FINAL PLAT
HIDDEN ESTATES ADDITION
AN ADDITION TO SEDGWICK COUNTY, KANSAS

RE: SUB 2002-58 -- One-Step Final Plat of Hidden Estates Addition

RE: SUB 2002-58 -- One-Step Final Plat of Hidden Estates Addition

CASE NUMBER: SUB 2002-58 -- HIDDEN ESTATES ADDITION

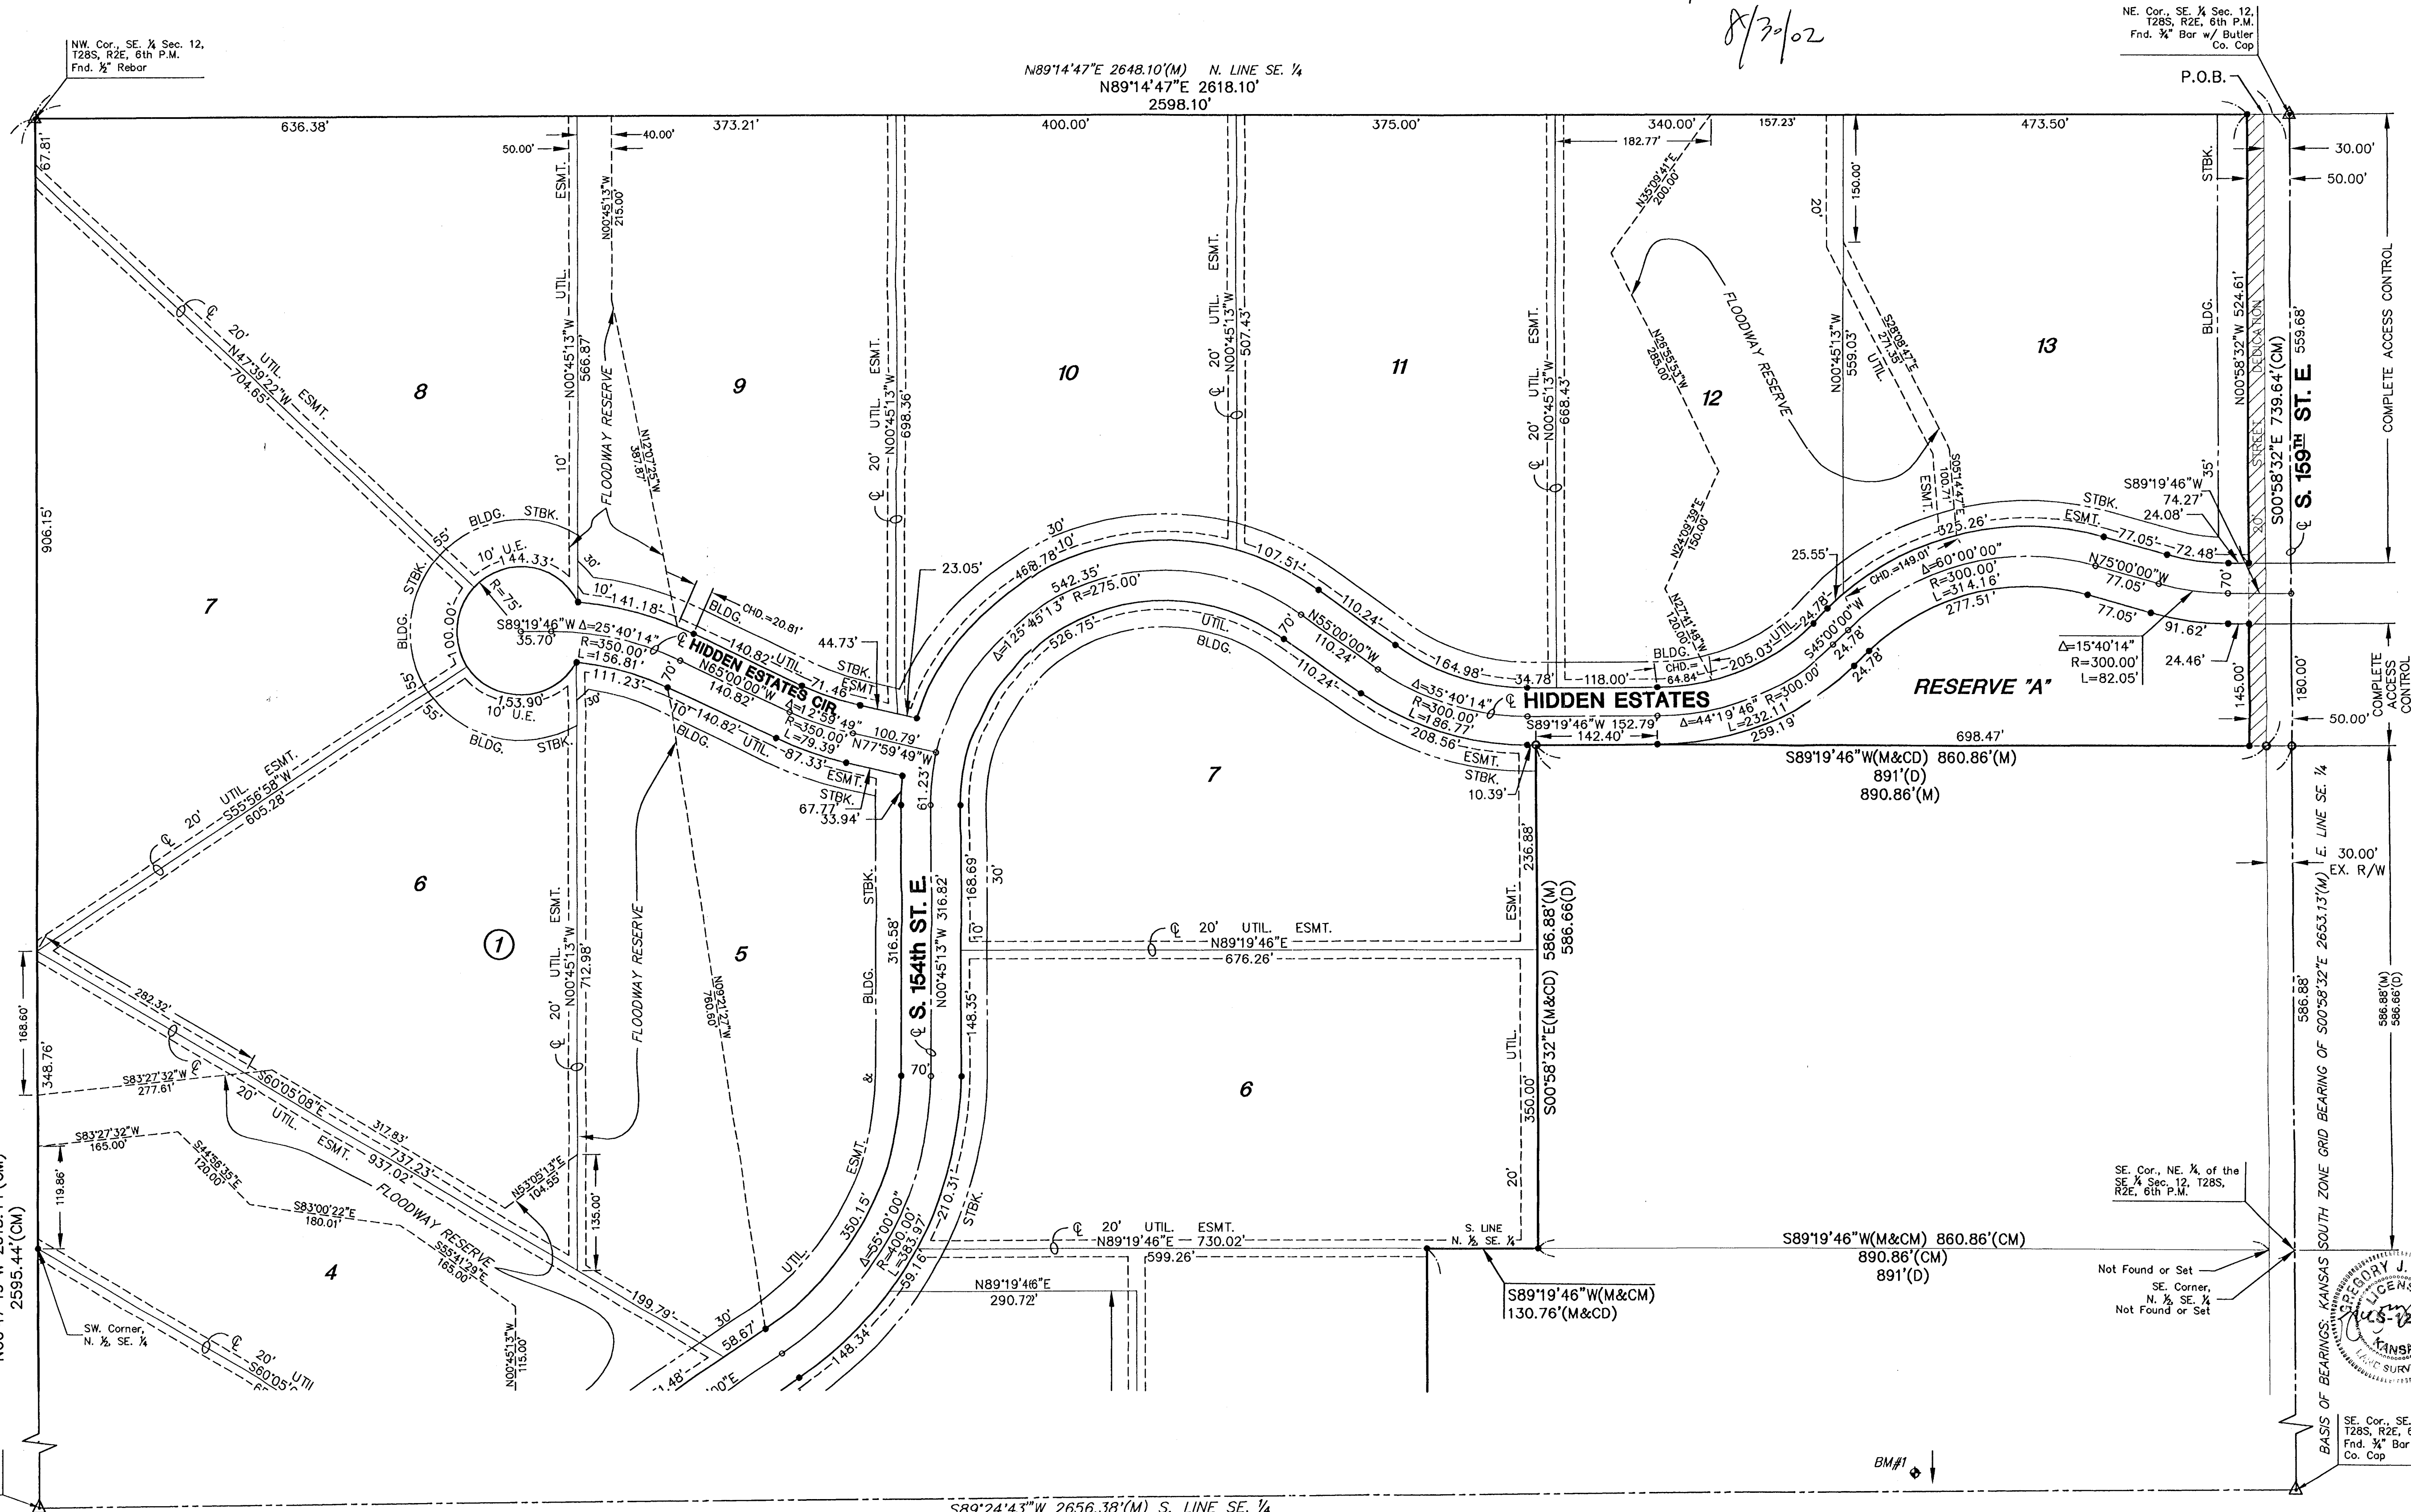
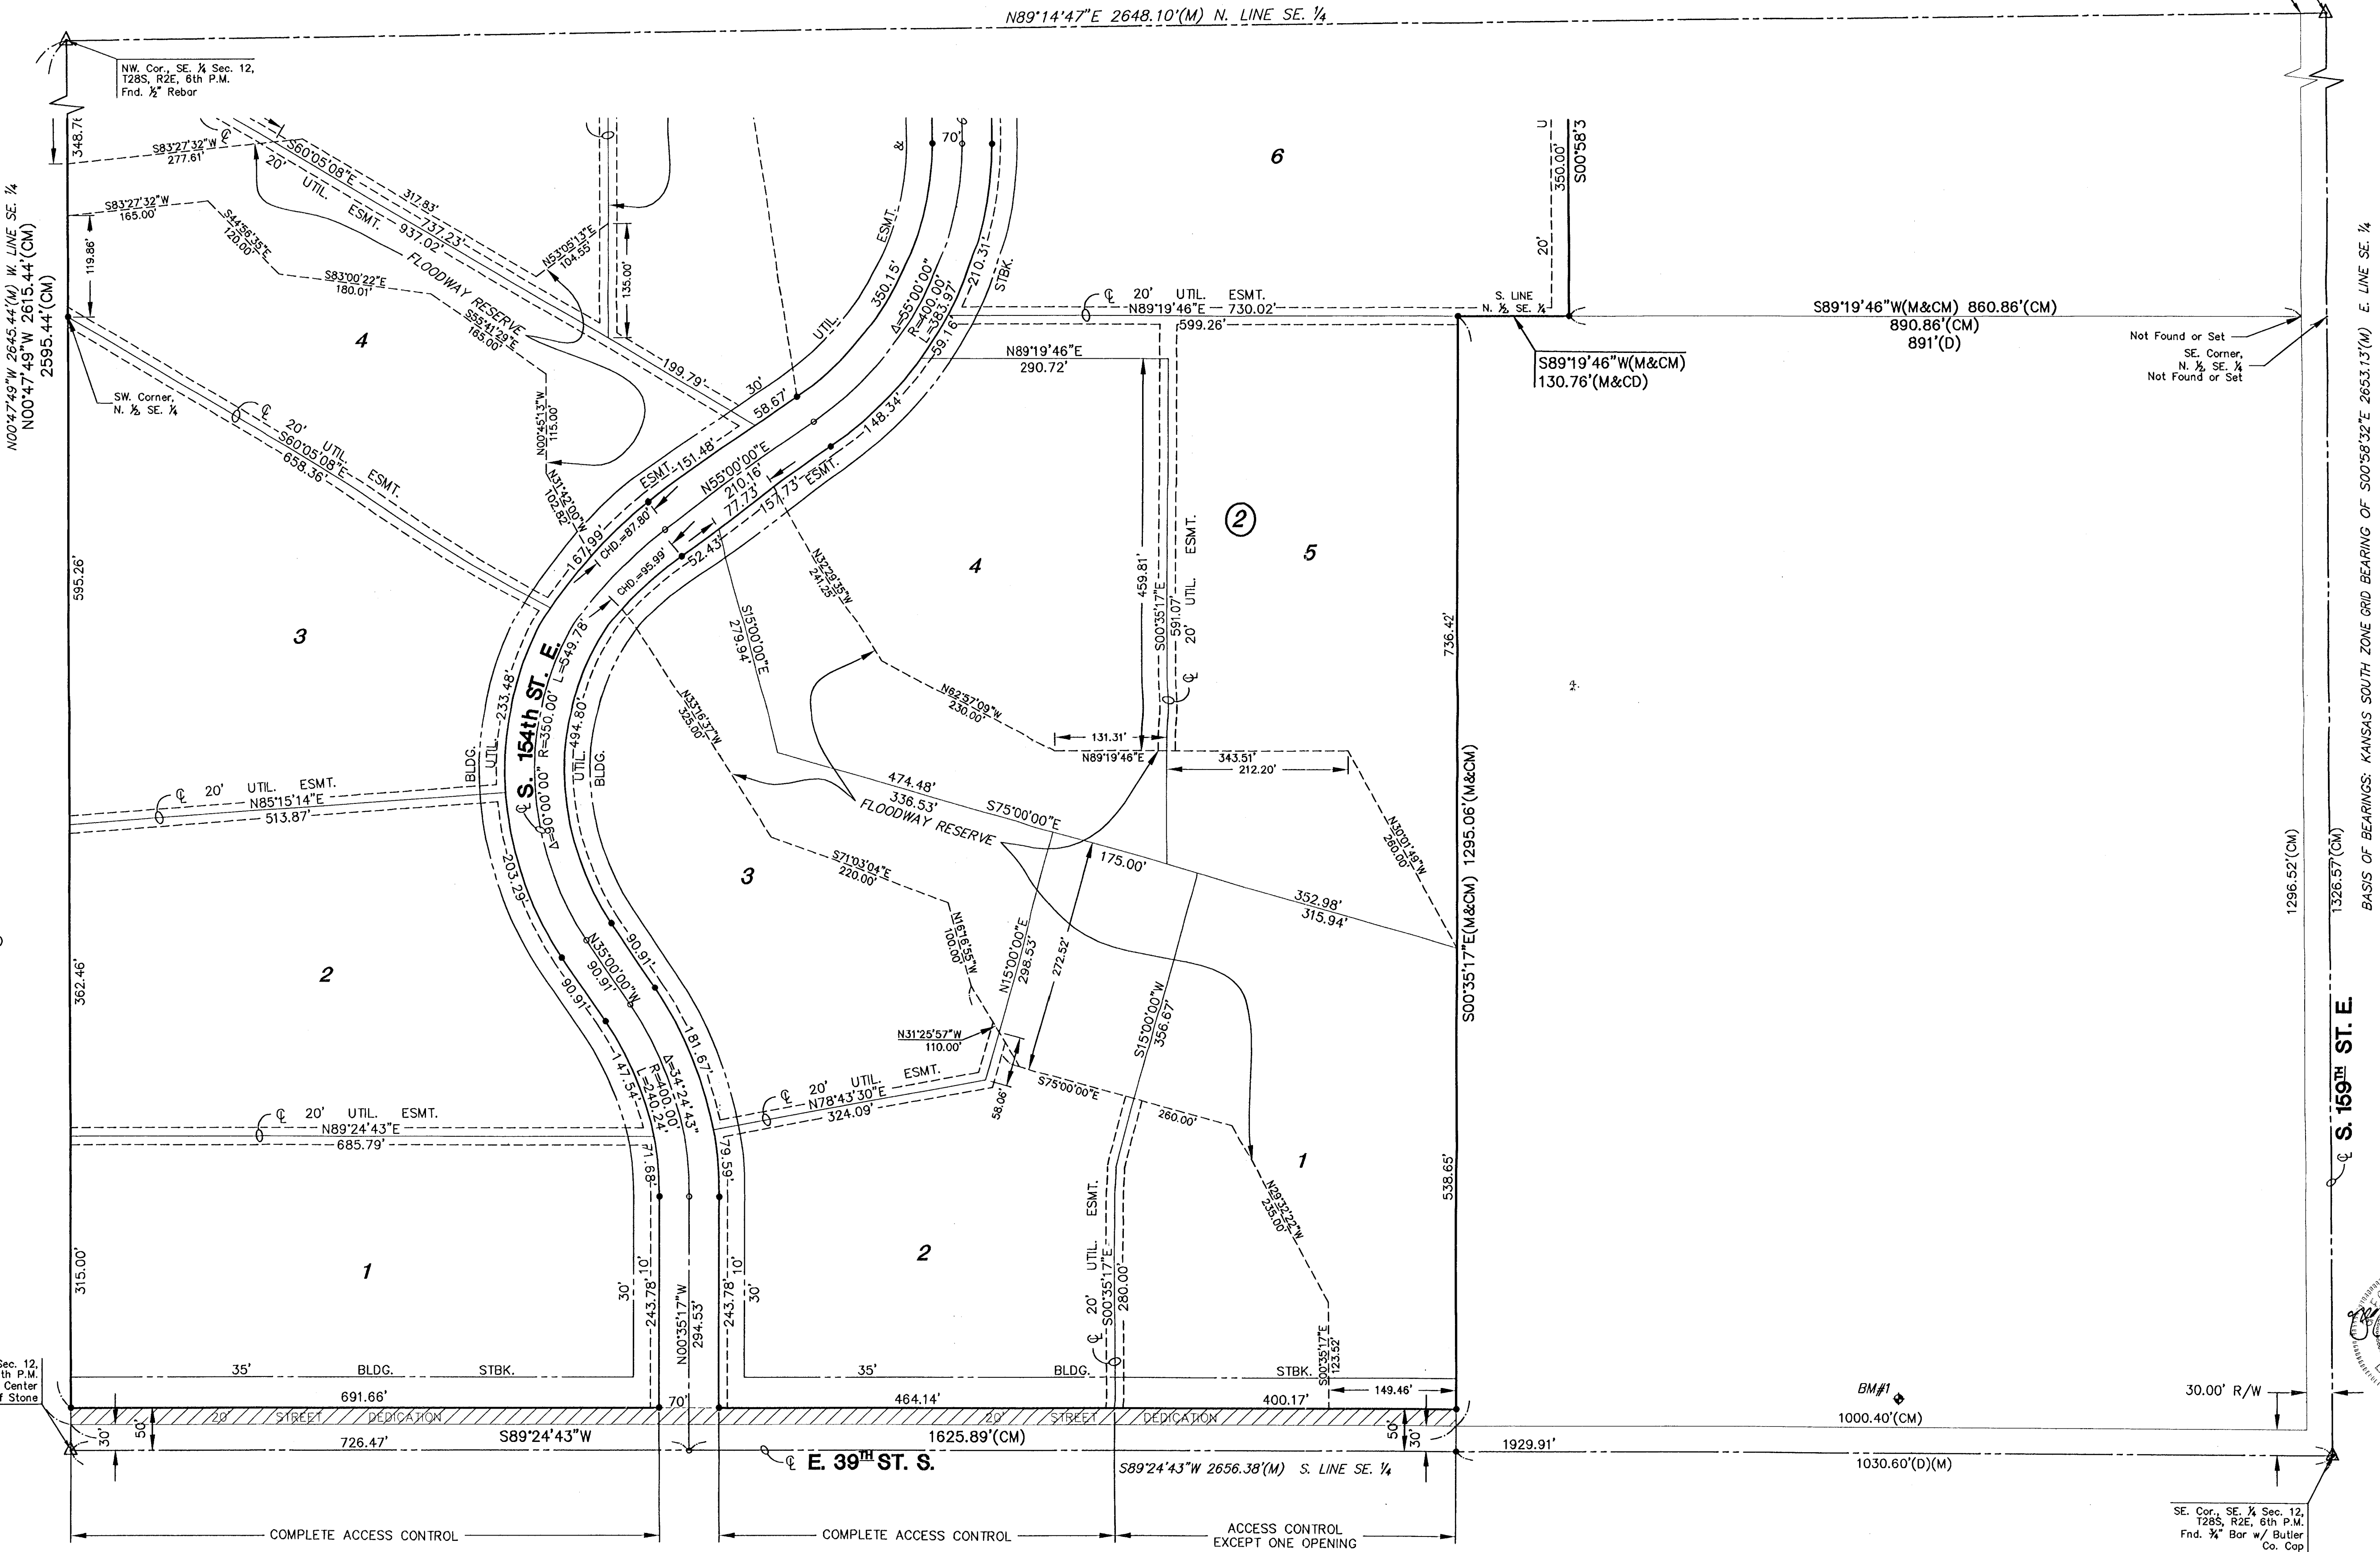
- D. County Engineering needs to comment on the status of the applicant's drainage plan. Drainage easements need to be located in floodway reserves. The standard floodway language needs to be included in the plat's text.

- E. County Engineering needs to comment on the access controls. Complete access control has been platted along the plat's frontage to perimeter streets. Lot 1, Block 2 has been platted with no access. County Engineering has recommended access on the west side of Lot 1, Block 2.

- F. The Subdivision Committee has requested utility easements between the lots.

- G. County Surveyor has advised that all deltas need the "?" changed.
- H. County Surveyor has advised that Lot 5, Block 2 needs a dimension at the northwest corner.

- I. County Engineering has required that the street layout be reconfigured to connect to the street to the north. MAPD requests a street connection to the west. *Due to drainage constraints, these conditions were not approved by the Subdivision Committee.*

- N. The right-of-way widths should be denoted for the internal streets.
- O. The cul-de-sac bulb needs to be increased to a 75 feet radius.
- P. Provisions shall be made for ownership and maintenance of the proposed reserves. The applicant shall either form a lot owners' association prior to recording the plat or shall submit a covenant stating when the association will be formed, when the reserves will be deeded to the association and who is to own and maintain the reserves prior to the association taking over those responsibilities.

- S. The Applicant is advised that if platted, the building setbacks along 159th St. East and 39th St. South must be 35 feet to conform with the Zoning setback standard for County section line roads.

- T. Lots 6, 7, and 8, Block 1 do not conform with the 200-ft lot width standard which is measured at the building setback line. An increase in the distance of the building setback from the road would meet the standard. The lot widths will be revised upon increase of the cul-de-sac bulb diameter.

- U. Lot 7, Block 1 does not meet the 100-ft lot frontage requirement. The frontage will be revised upon increase of the cul-de-sac bulb diameter.
- V. Approval of this plat will require a waiver of the lot depth to width ratio of the Subdivision Regulations for Lots 6, 7, and 8, Block 1. The Subdivision Regulations state that the maximum depth of all residential lots shall not exceed 2.5 times the width. The lot depth to width ratio will be revised upon increase of the cul-de-sac bulb diameter.

- W. The County Fire Department/GIS needs to comment on the plat's street names. Arterial street names need to be corrected on the face of the plat and in the plat's text. The east/west Hidden Estates Parkway should be revised to Hidden Estates. The north/south Hidden Estates should be revised to "S. 154th St. E."
